RE: Leyden Pit Permit No. M-1983-139; Adequacy Review No. 2 (AM01) Response

Please find the responses to the concerns identified in the Adequacy Review No. 2 (AM01).

PLAN OF EXISTING CONDITIONS, BOREHOLE LOCATIONS AND SURVEY CONTROL

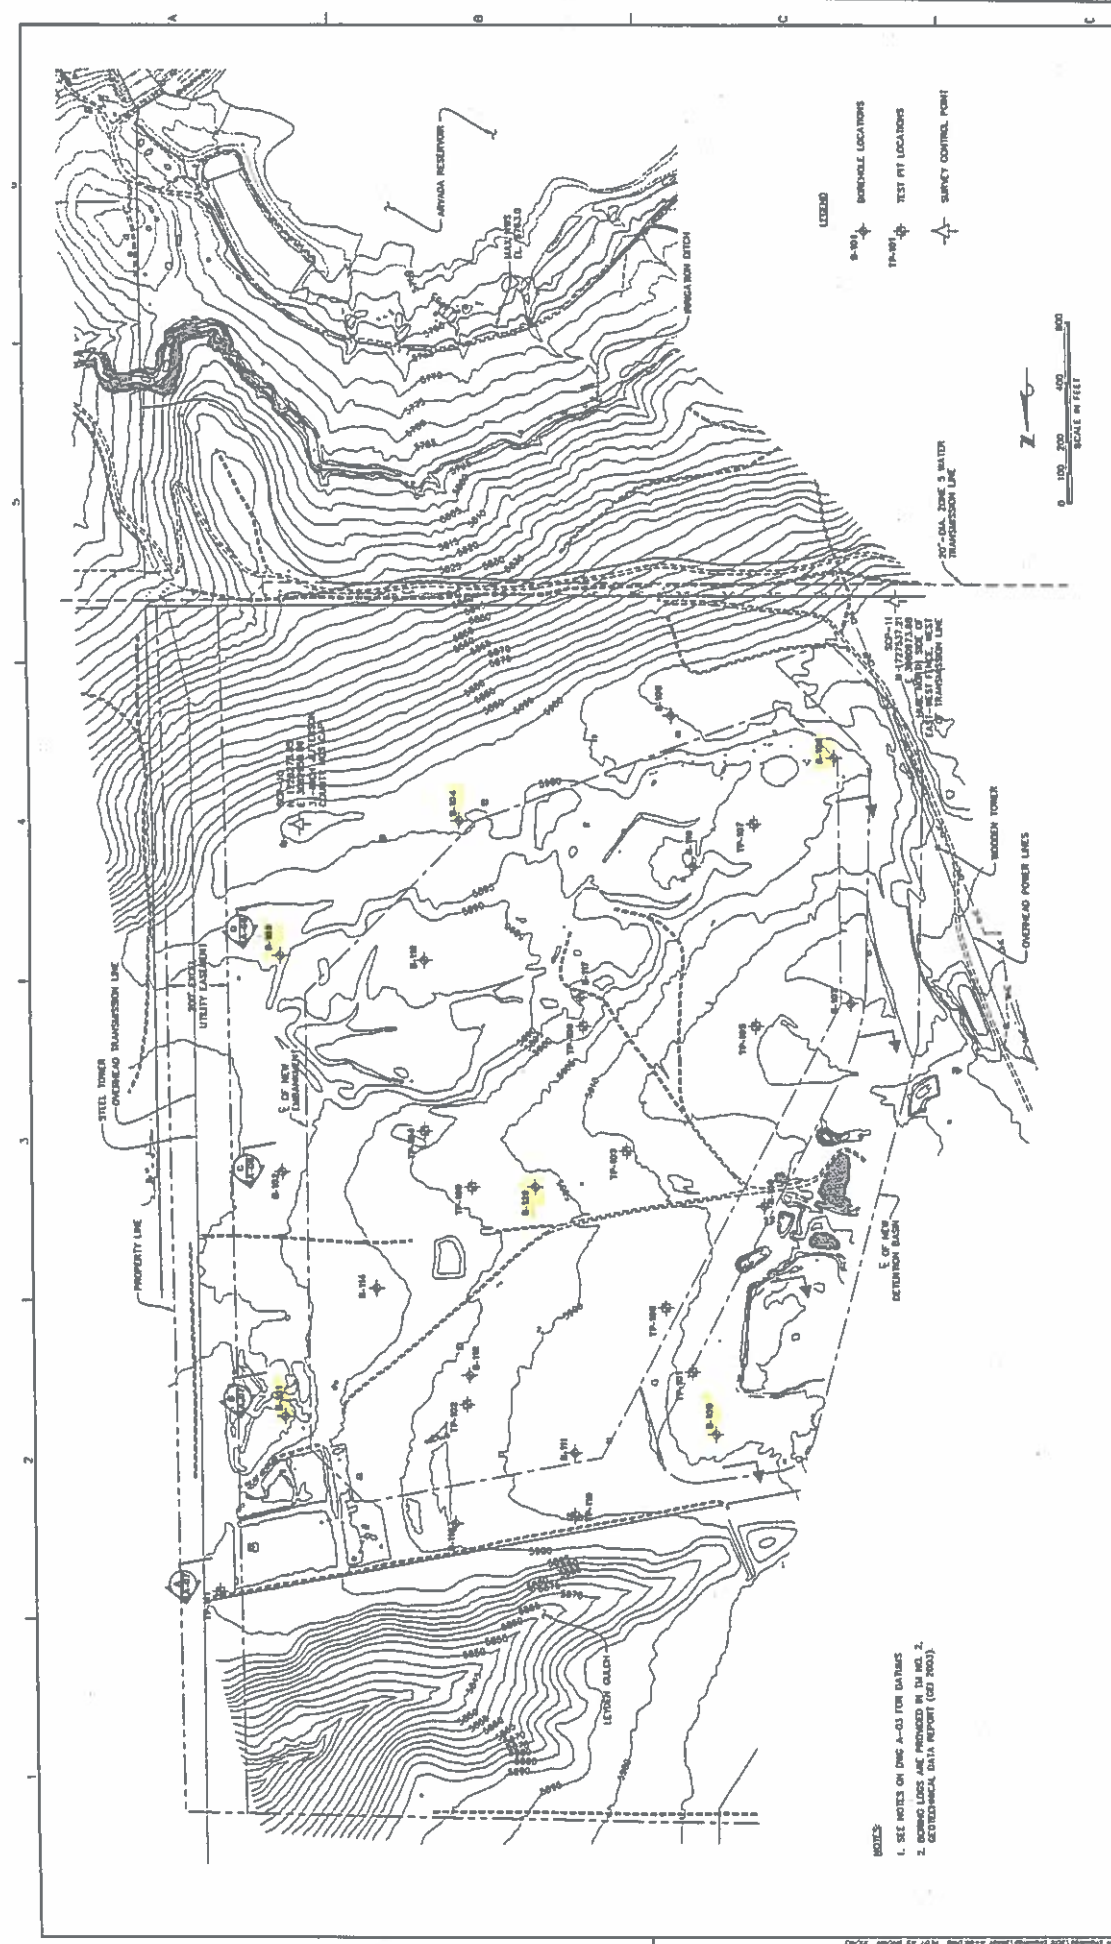
- c. As requested, the city of Arvada was able to locate a few wells on the site that were listed in the February 16, 2018 Table 2. Refer to the attachment, Map 3, to see the boreholes drilled which are associated with located wells. It is assumed that these wells match up with the monitoring wells listed within the DWR well permit map viewer (Map 4). The City of Arvada took groundwater levels during the week of March 5, 2018. Table 1 below explains the findings.

- 250173: this well is within the permit location. Looking at the attached Map 3, it is assumed that this well could also be referred to as B-102. This well was not able to be located during the site visit.

To Leyden Gulch

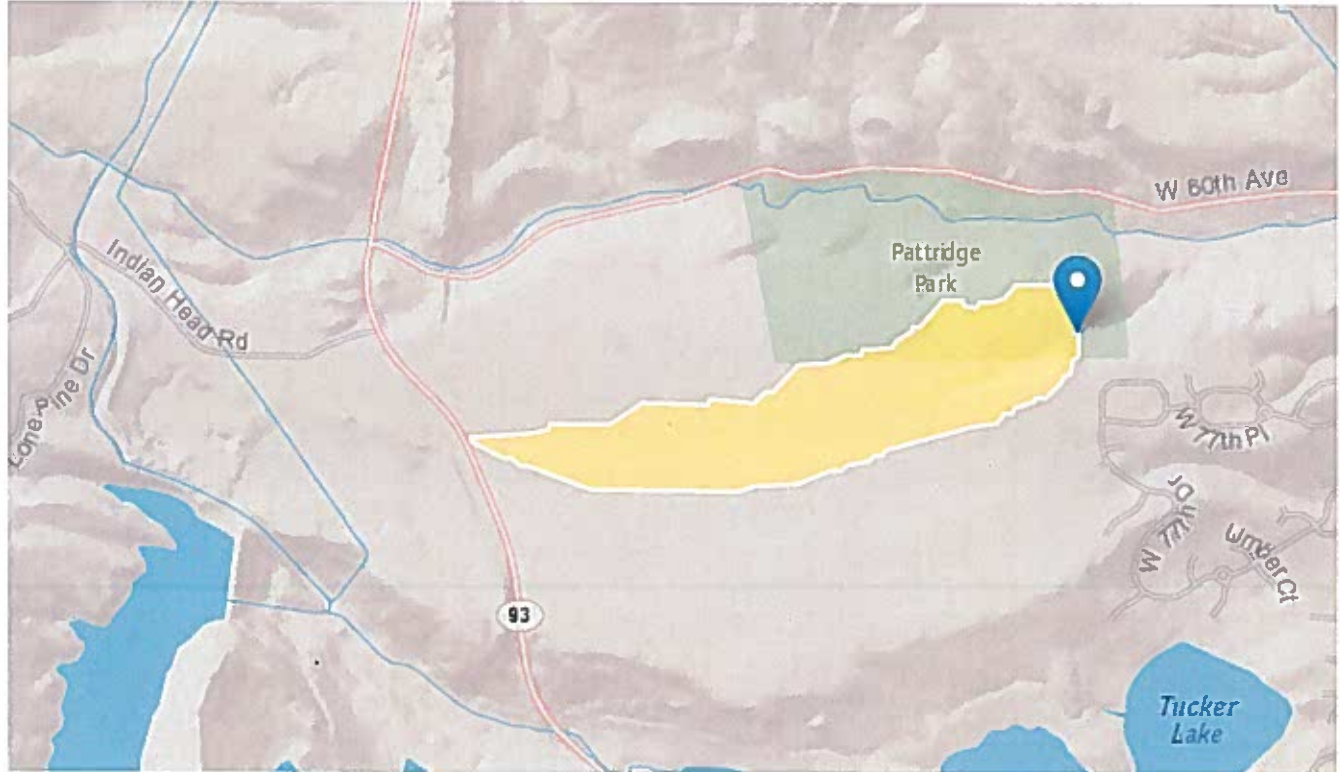
2. Additional information required to demonstrate that a Temporary Substitute Water Supply Plan will not be required is as follows:
 - a. Please refer to Map 1, attached, for the source of the impounded surface water. The general drainage on the site runs from west to east with a slight northeast slope in the northern portion of the site and a slight southeast slope in the southern portion of the site. Map 1 shows two shaded polygons, these come from USGS StreamStats application. Refer to the attached StreamStats reports for both the drainage to Leyden Gulch and Moon Gulch.
